# Featured Products Bulletin

PRECISION POTENTIOMETERS

## Model 3590 Update

*New shaft with c-ring*

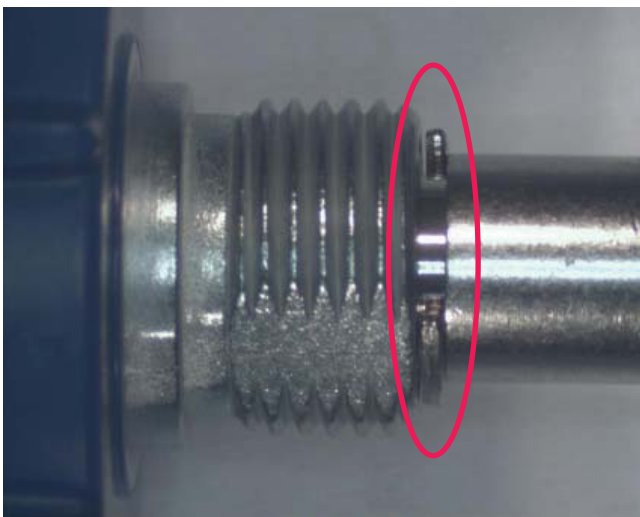
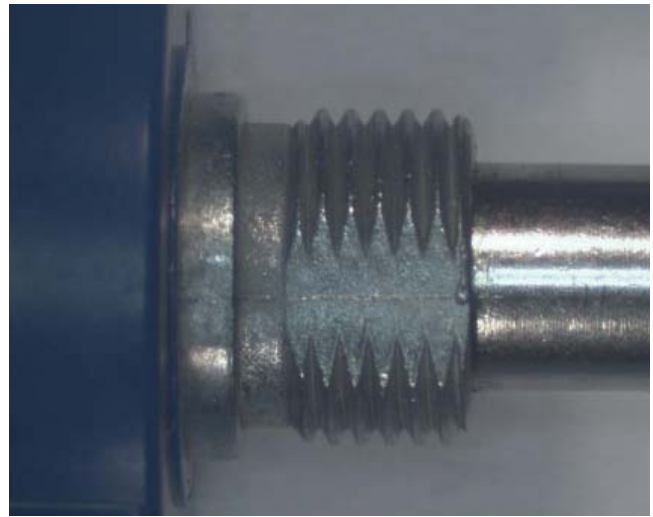
In order to build a more robust product, we are now adding a c-ring to the base of the shaft. The addition of the c-ring reinforces the shaft from axial loads exerted on the shaft that may occur when installing gears or other mechanical couplings.

The photos below show the shaft with and without the c-ring.

This upgrade is being done on the metal shaft/metal bushing versions of this model only. The plastic bushing/plastic shaft versions will not have the c-ring. The c-ring upgrade was implemented in production beginning with date code 0913M.
